SUBJECT: Modifies 830308 commitment re performance of surface exam on
 100% of weld over 40-yr period, per util request for relief
 from performing volumetric exams of reactor coolant pump
 welds. Sections of welds will be examined over 30-yr period.

Docket 50-305
Operating License DPR-43
Kewaunee Nuclear Power Plant
Clarification of RCP Exam Relief Request

FIGURE 1

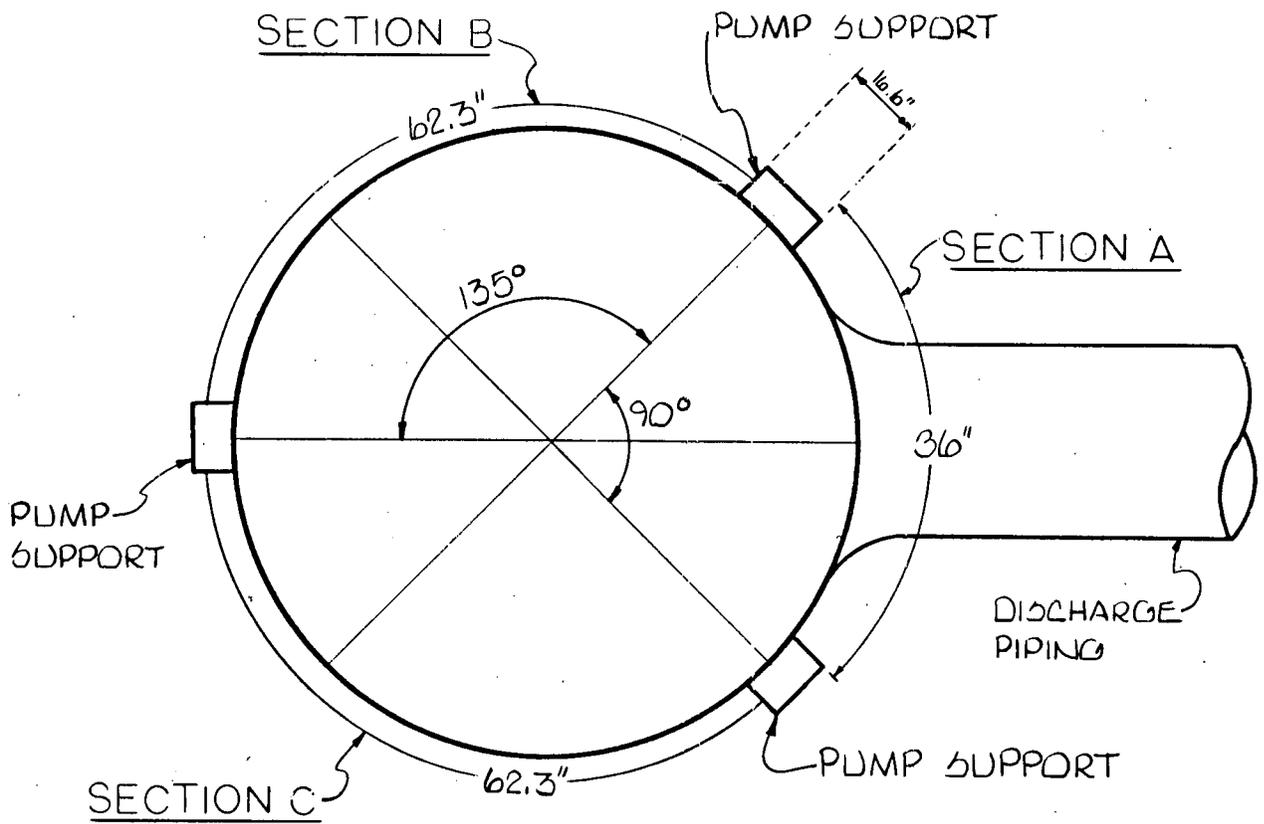
During performance of the surface examination during our latest refueling outage, it became apparent that portions of the weld are inaccessible from the exterior due to the reactor coolant pump structural supports. There are three pump supports located such that approximately 24% of the weld length is inaccessible (see figure 1).

the weld over a 30-year period. A different section of the accessible weld will be examined during each 10-year interval, with a section being defined as the accessible area between two pump supports. Section A (Figure 1) was examined during our most recent refueling outage and sections B and C will be examined over the next two intervals. This inspection plan will provide for surface examination of 100% of the accessible weld over three 10-year intervals (30 years).

Due to the inaccessibility of portions of the weld because of the reactor coolant pump supports, we intend to examine the entire accessible portion of
